**ADDENDUM 2**

**ALTERNATE BID DESIGN**

**Median Islands With Beveled Curb And Cobblestone Infill**

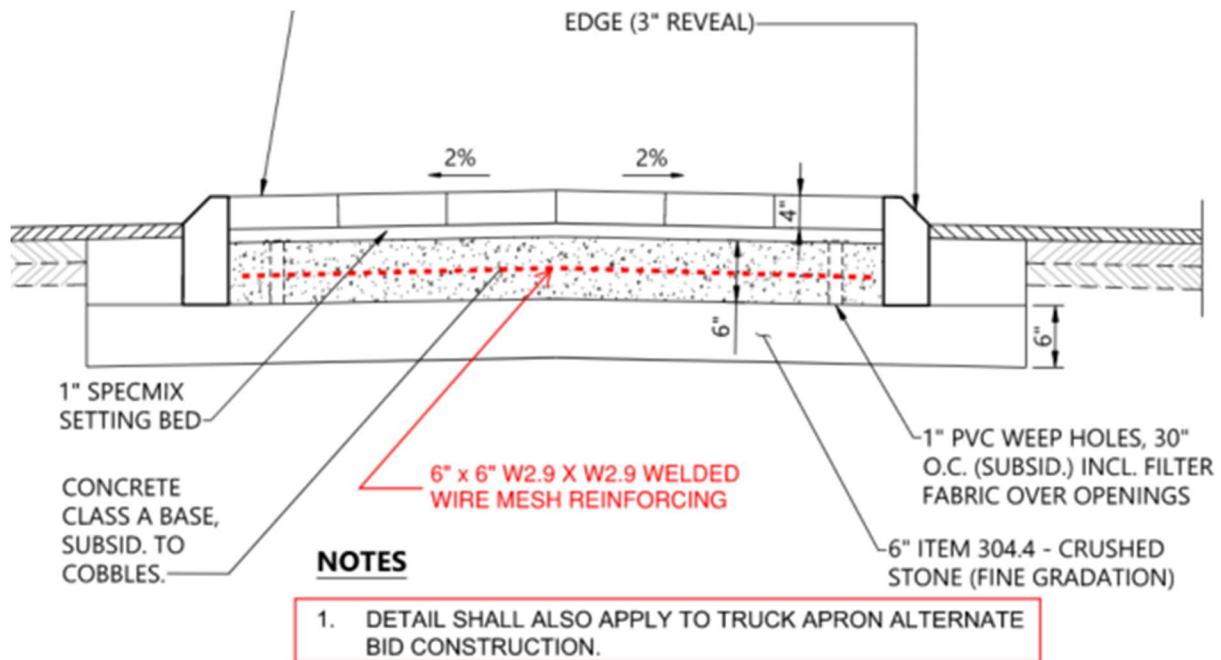
The bidder asked whether the concrete base under the cobblestone truck apron under the cobblestone alternate bid item needs to be reinforced, and if so, would the reinforcing differ from the reinforcing noted in Addendum 1 for the concrete truck apron?

The answer is that the reinforcing for the 6" concrete base under the cobblestone setting bed shall be 6" x 6" W2.9 x W2.9 Welded Wire Fabric. It is not as critical to resist cracking since the concrete base would not be visible under the cobblestones, but the wire mesh would serve to resist heaving of any cracked pieces.
